SEWAGE DISPOSAL SYSTEM
HOWARD COUNTY HEALTH DEPARTMENT
BUREAU OF ENVIRONMENTAL HEALTH
410-313-2640

P 514663-B

RE: Building Permit Application B00127102
3100 Roxbury Mills Road
Proposed Large Addition w/Proposed Bedrooms

514663-B

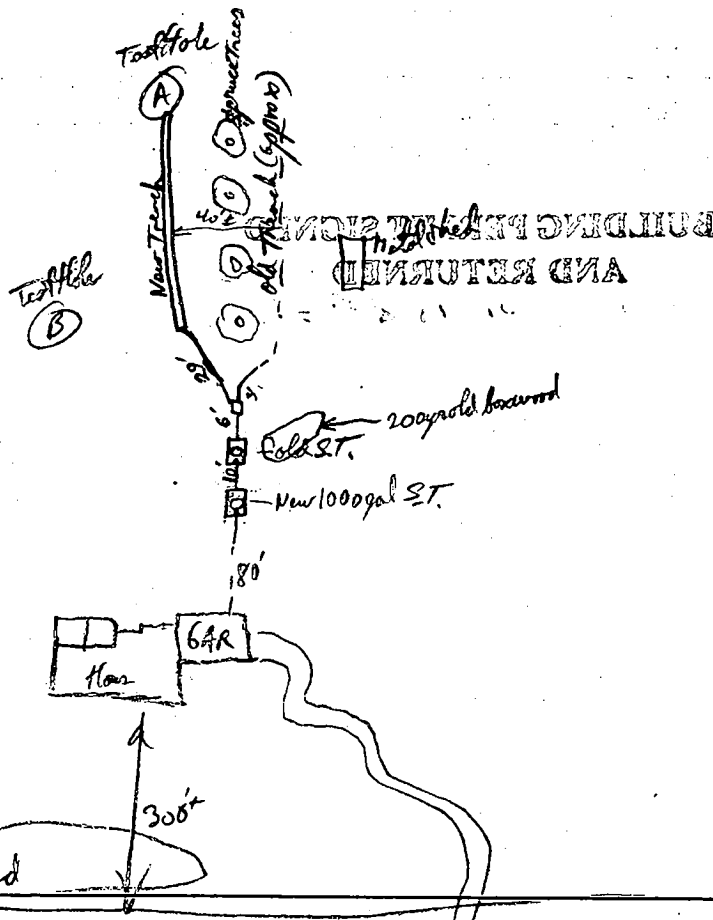
Call for inspection when ground is opened so sanitarian can recommend repair. 11/29

12/1/00 SPECS ISSUED FOR TRENCH ON OTHER SIDE OF TREES FROM
EX. TRENCH (MUR)

INSPECTION COMMENTS: New Septic Tank and connecting Sch 40 piping installed. Did two perc tests
to verify. Revised SDA. Replacement Trench to be installed tomorrow 12/5/00. Had Sealed Tank
Needs water tightness test. 12/6/00 New Trench Installed, gravel filled, OK to finish trench then cover all
work, S.T. is OK (I.P. + cover) Dist. Box OK. 12/6/00

P 34985
A REPAIR

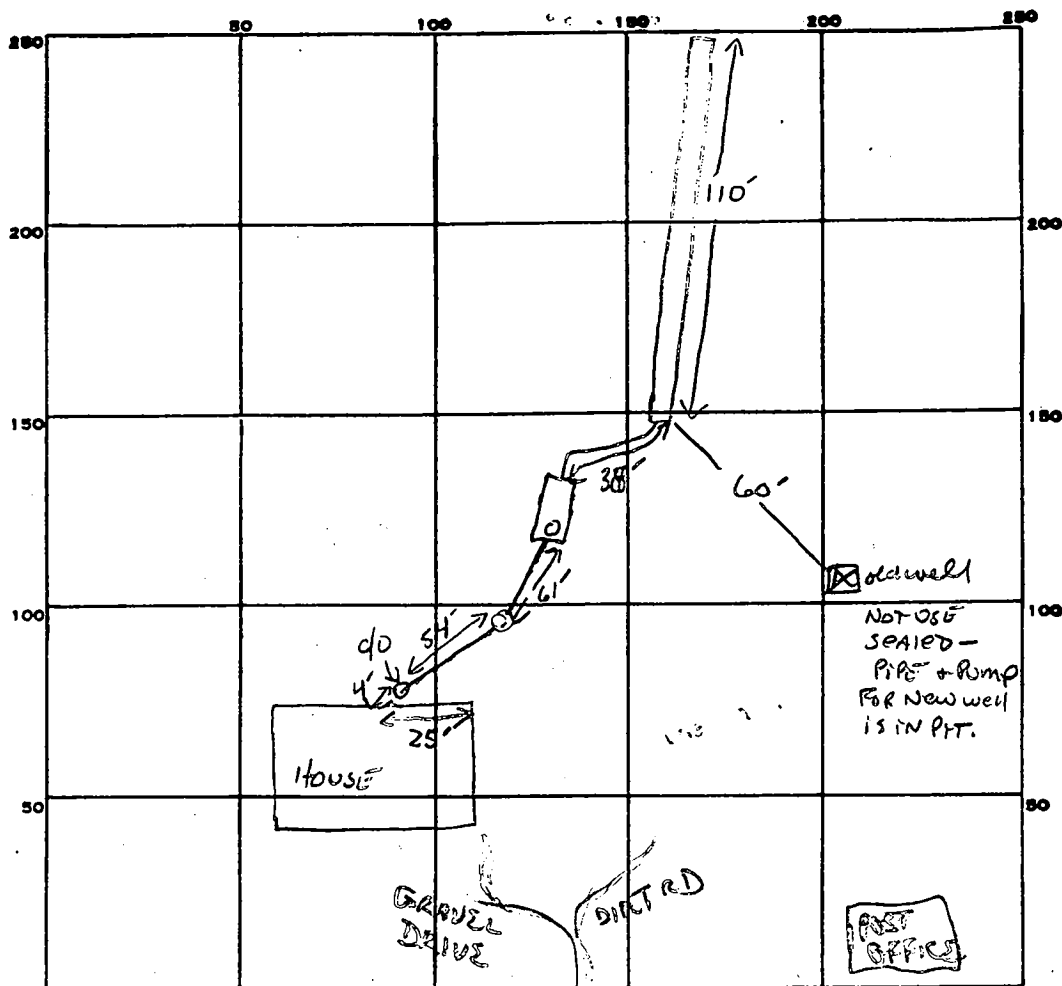
Replacement System; 200 ϕ /BR; INLET 5 FE BOTTOM 10 FE; 5' STONE Below P.P.O.
PLACE SYSTEM 165 FE FROM BACK OF HOUSE AND 25 FE FROM SAND; RUN SYST.
ON Level ground; SAND 5-6-86 / 5-7-86 OK TO BOTTOM AT 10.5' S. SAND

REMARKS S-8-84 OK TO ADD STONE TO TRENCH; OK TO COVER ALL WORK; NEED TO SEE HOUSE CONNECTION.

5/19/86 House c/o with inline c/o verified. Rest of system already covered.

REVISED SEPTIC AREA FOR HOUSE ON LOT 2

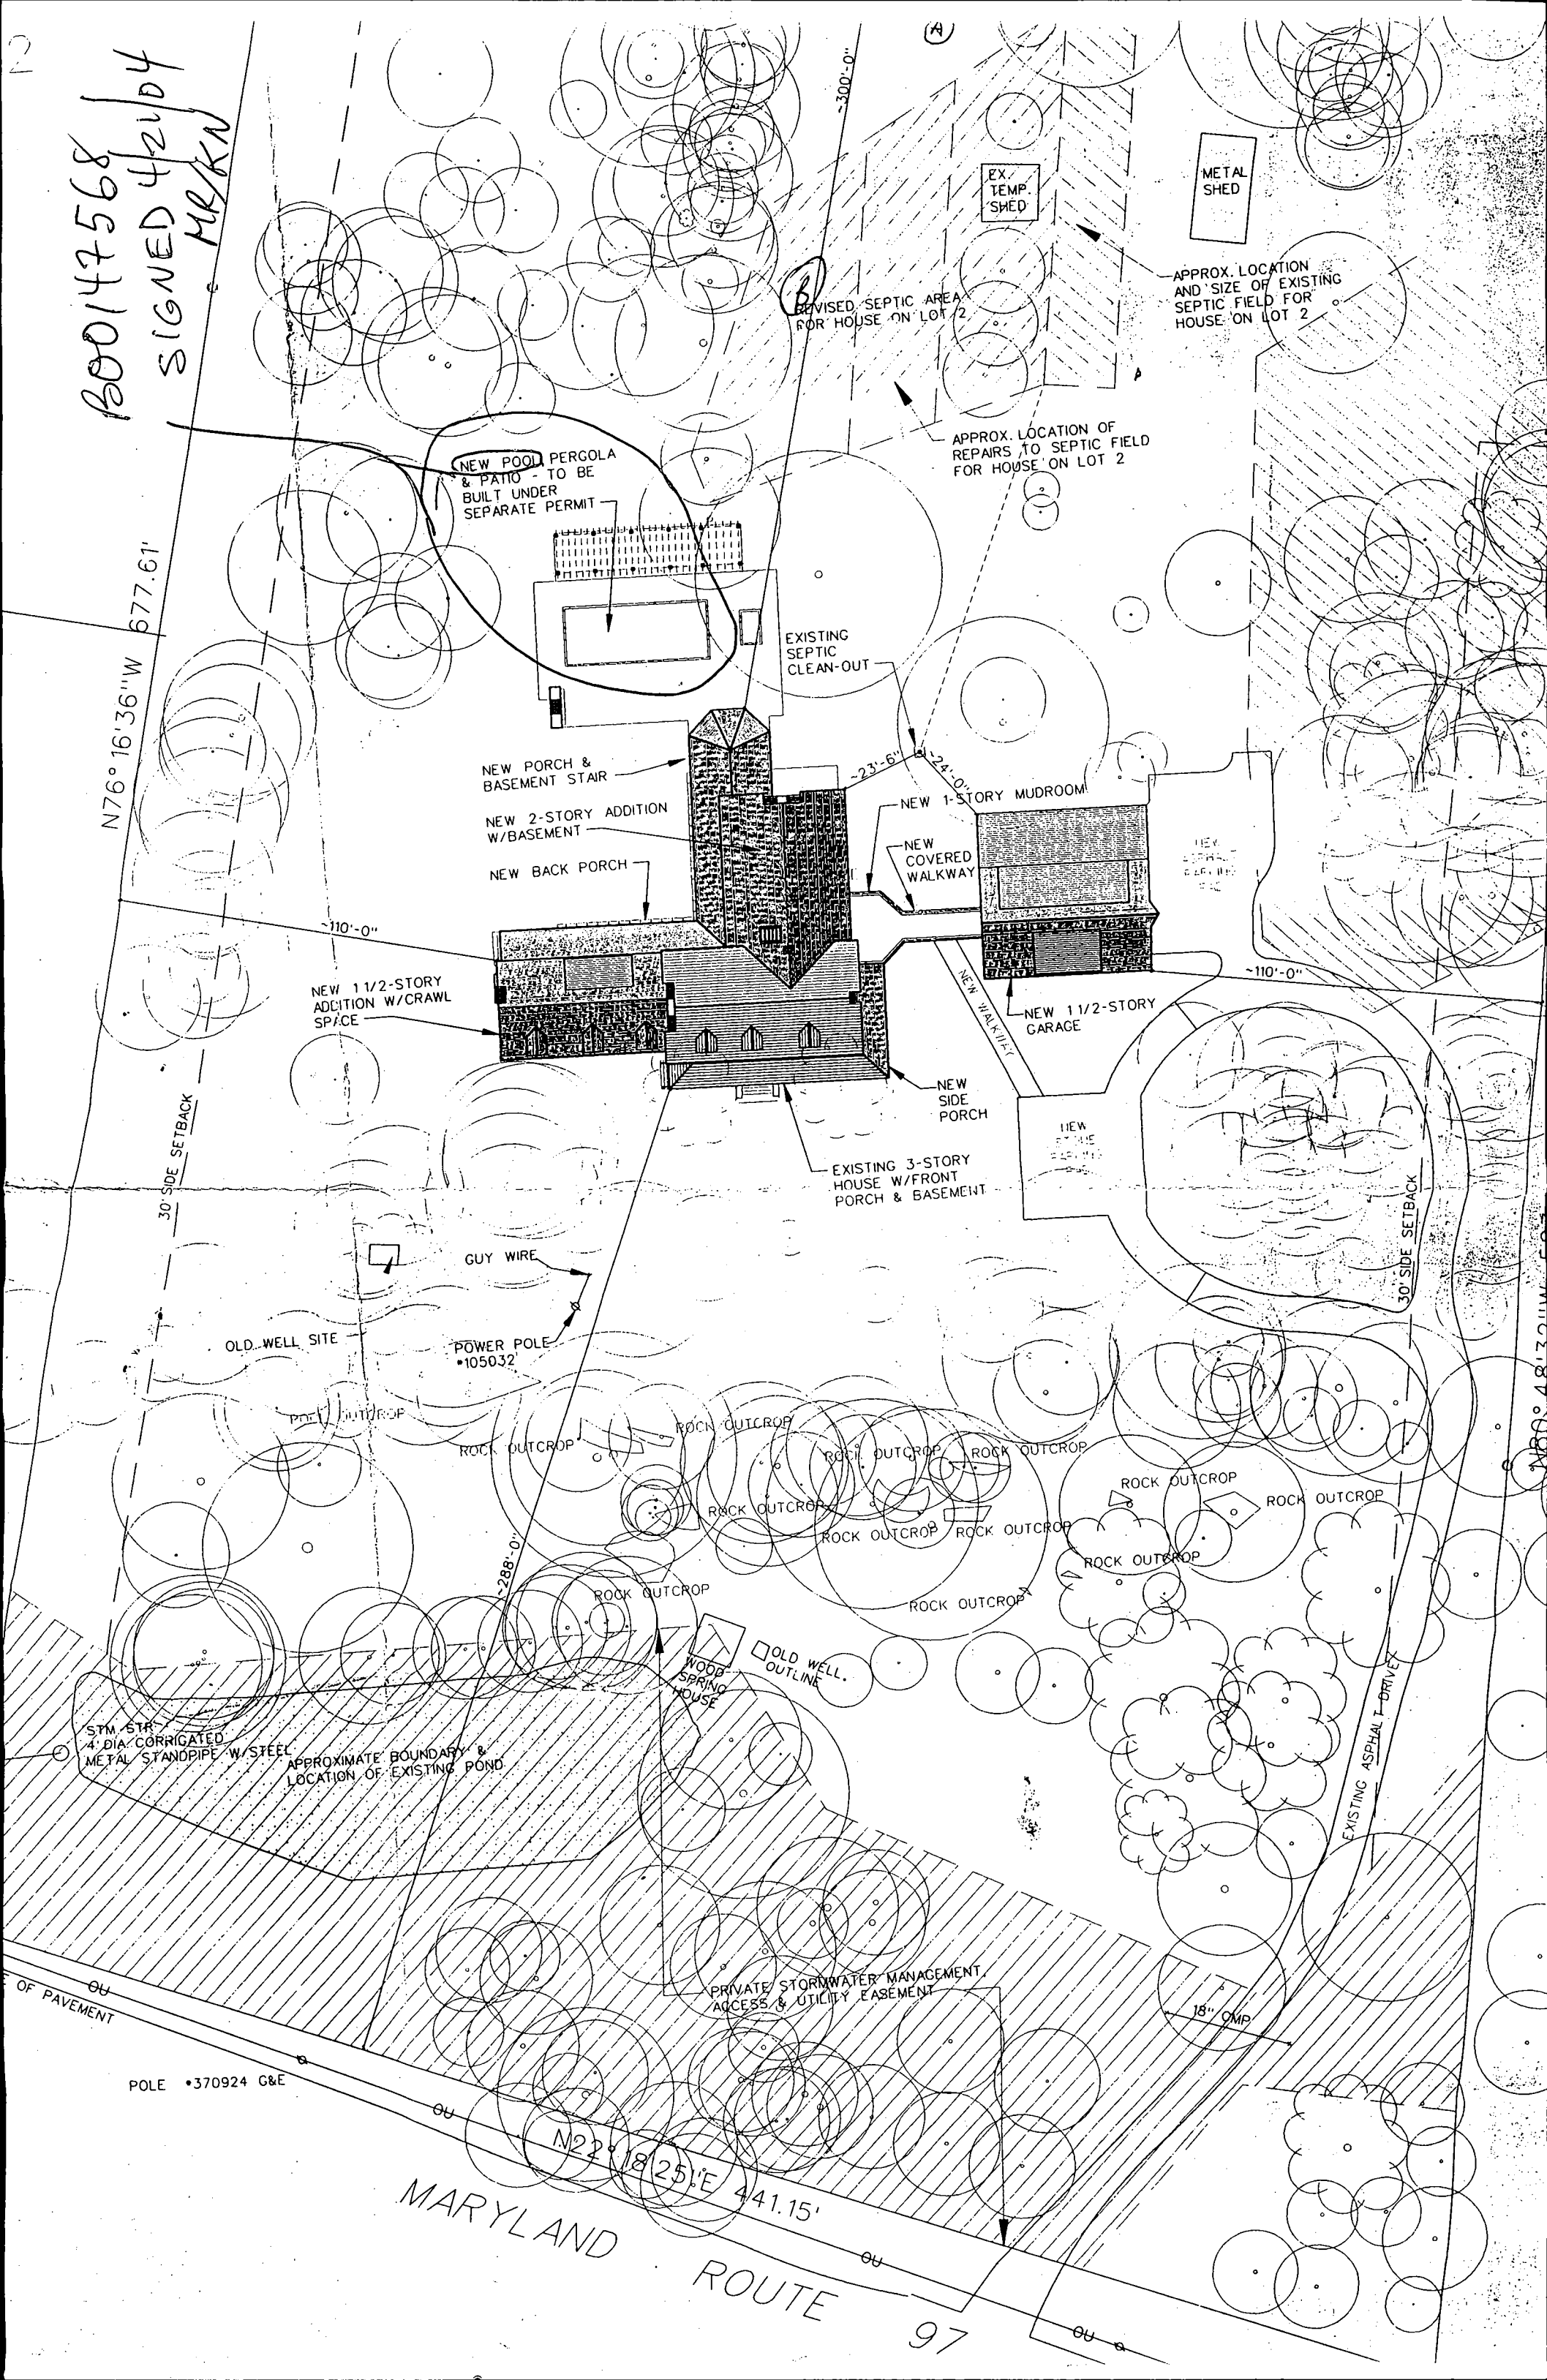
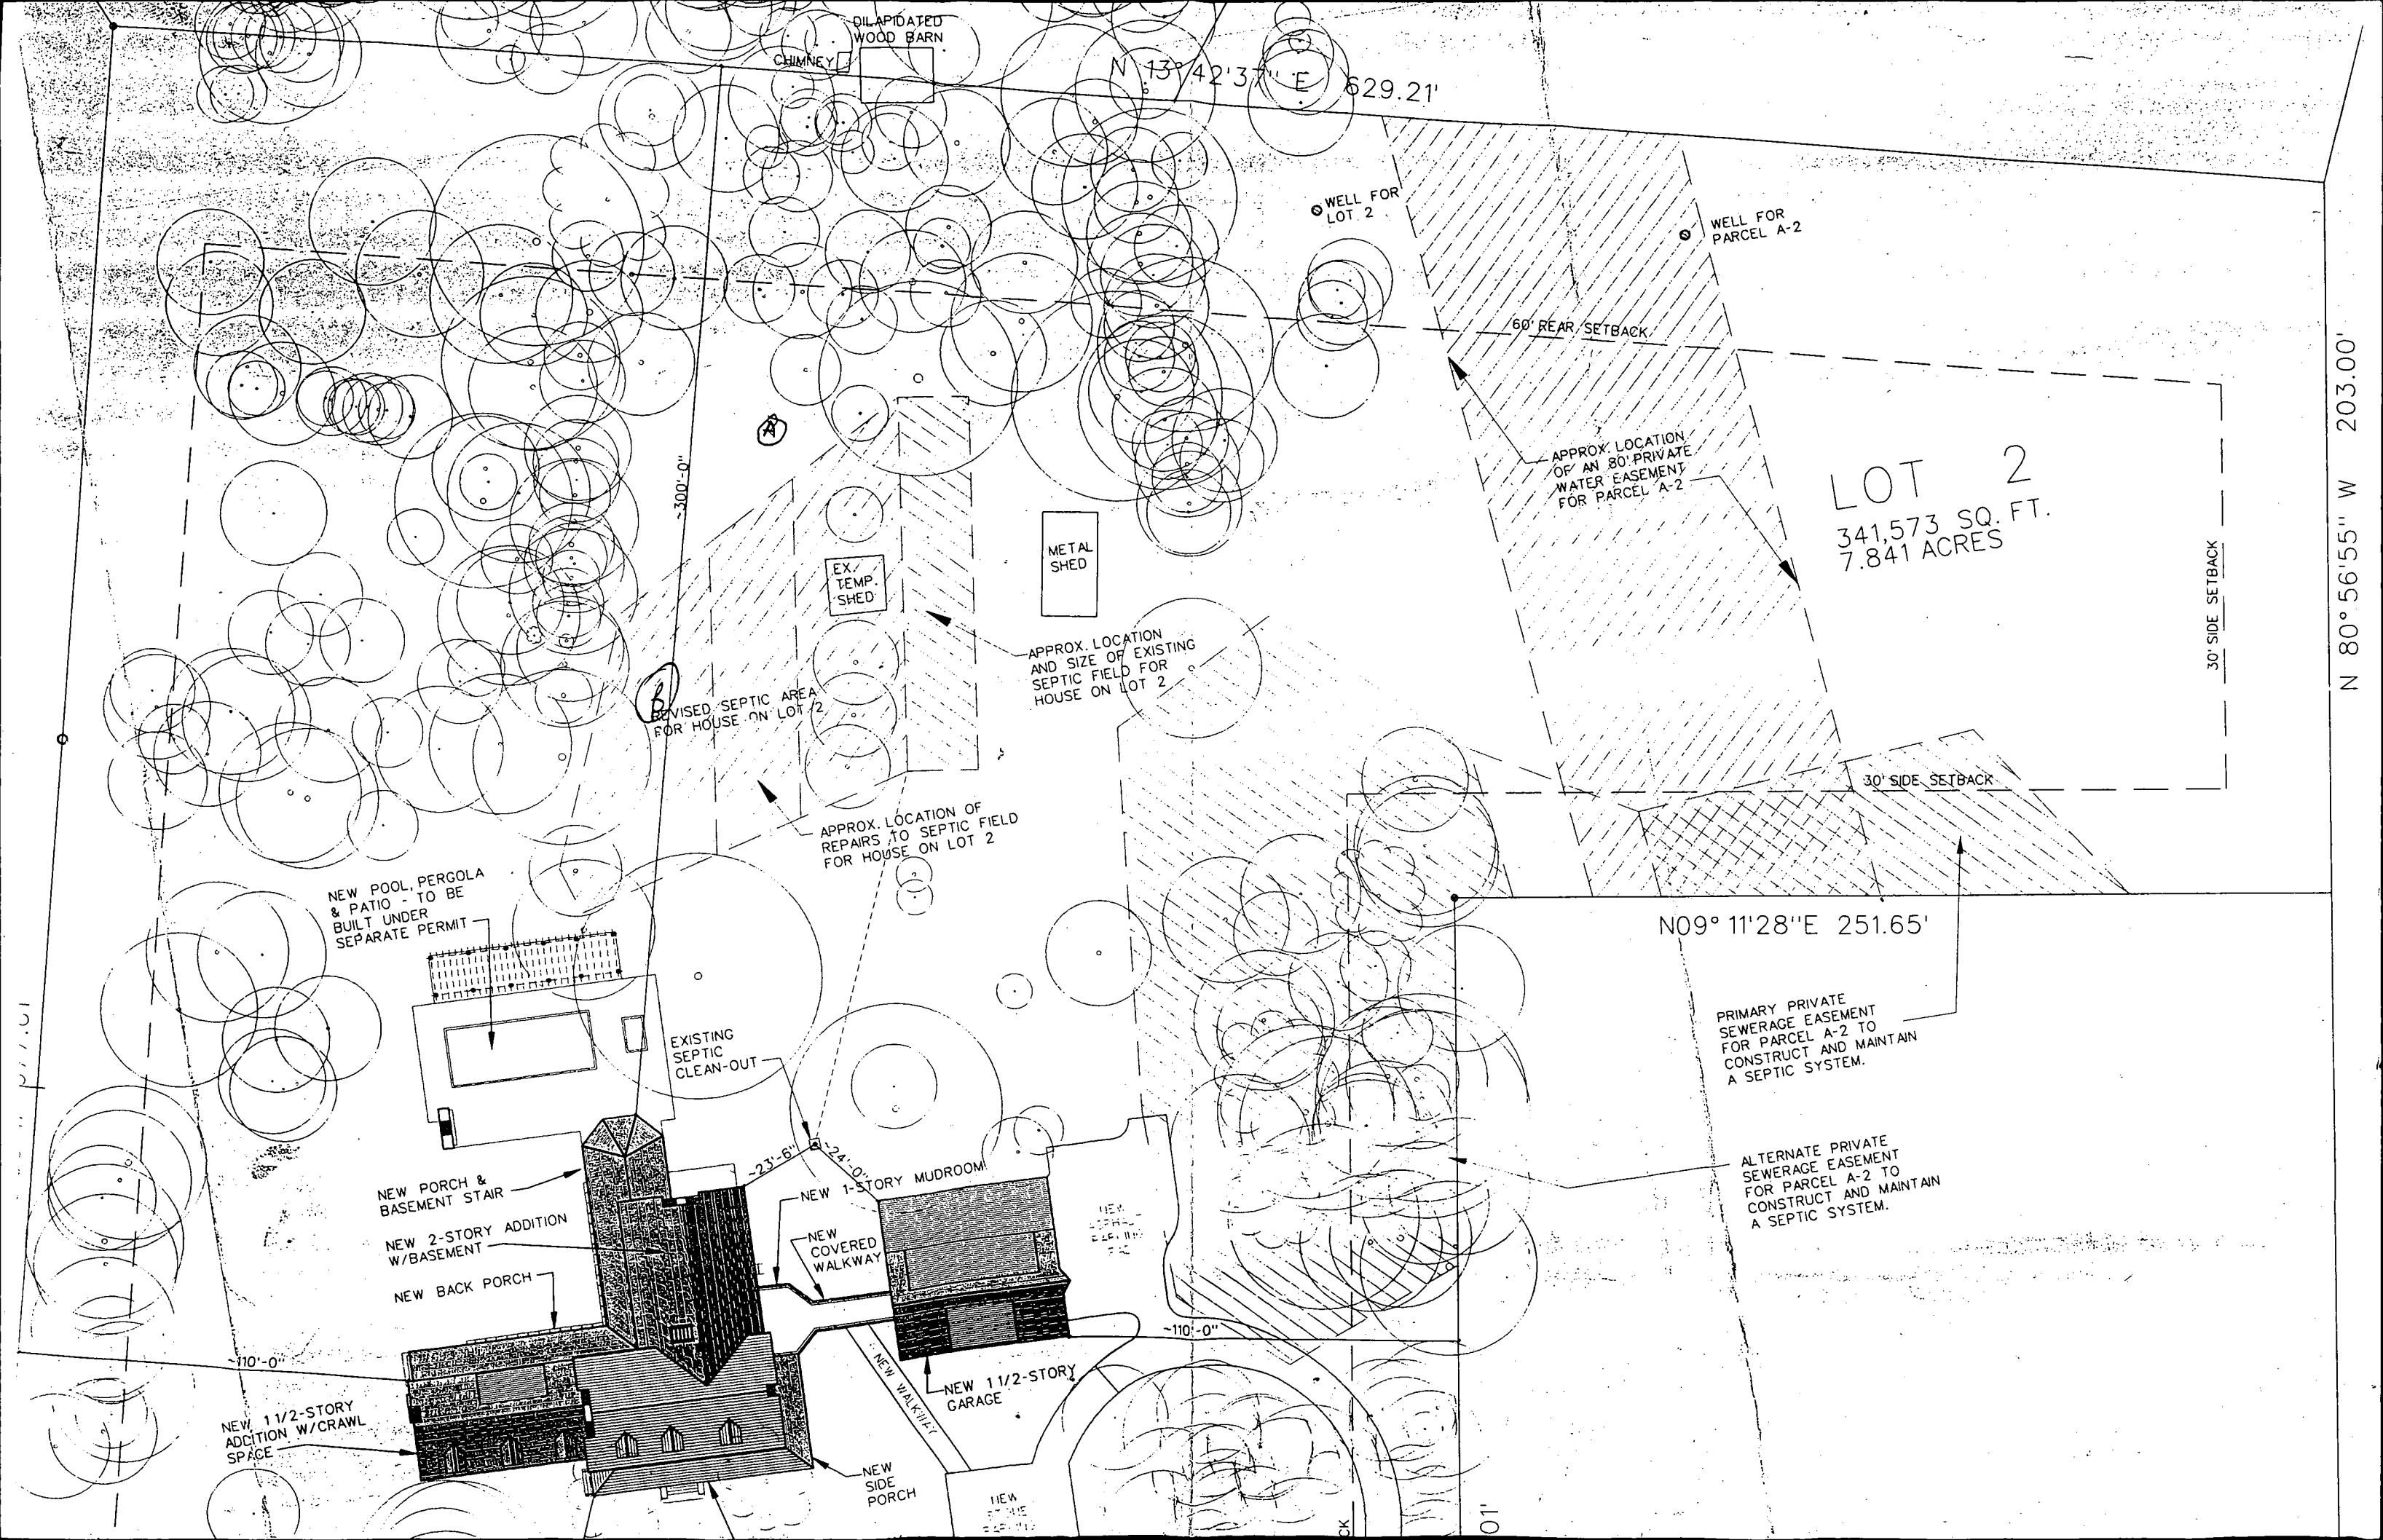
APPROX. LOCATION AND SIZE OF EXISTING SEPTIC FIELD FOR HOUSE ON LOT 2

APPROX. LOCATION OF REPAIRS TO SEPTIC FIELD FOR HOUSE ON LOT 2
